Current Zoning: N1-A (neighborhood 1 – A)  
Proposed Zoning: UR-2(CD) (urban residential, conditional)

The petition proposes to allow a 14-unit townhome development on a vacant parcel located between Park Road and Wintercrest Lane and on the north side of Fairview Road.

Staff recommends approval of the petition upon resolution of the outstanding issue pertaining to site and building design.

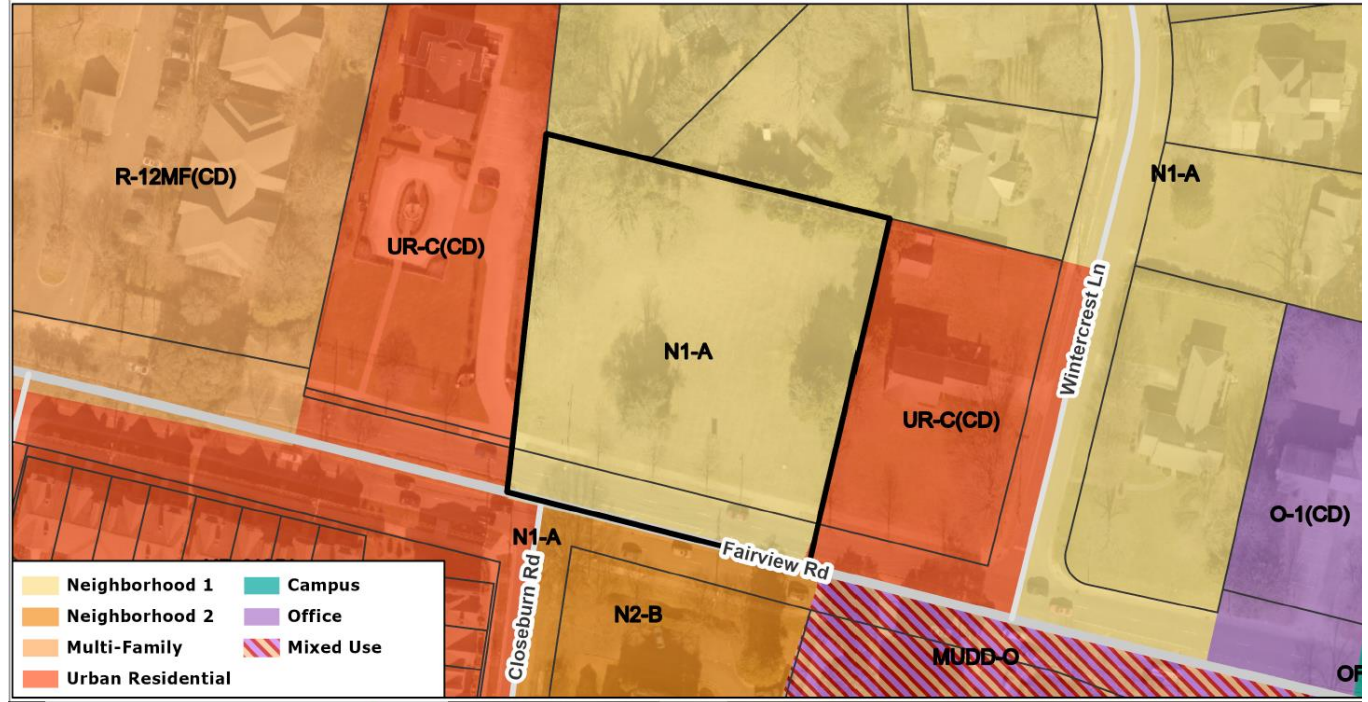
- ~~1. Limit the building height to 45 feet.~~ Addressed
2. Proposed eight-foot Class C buffer along east property line should be increased to 10 feet with language included it will not be reduced by 25%. **Update: There is a discrepancy between labeling on the site plan and Note V.2. Please revise so note matches the graphic depiction of a 10' wide buffer.**

- ~~4. Amend language to Limit the number of dwelling units in one building to four when fronting Fairview Road.~~ Addressed
5. The site plan shows a 15-foot sanitary sewer main line that runs parallel to a portion of the north property line. The petitioner needs to show and label the actual width of the sanitary sewer easement on the site plan. Provide a minimum 10-foot Class C buffer outside the sanitary sewer easement along the north property line. Show and label the buffer on the site plan and commit to this improvement in the development notes, specifying to not be reduced by 25%. **Not addressed**

**Petitioner's response: We are unable to make this commitment due to space limitations on site. We can commit to providing a buffer if the sanitary sewer easement is abandoned.**
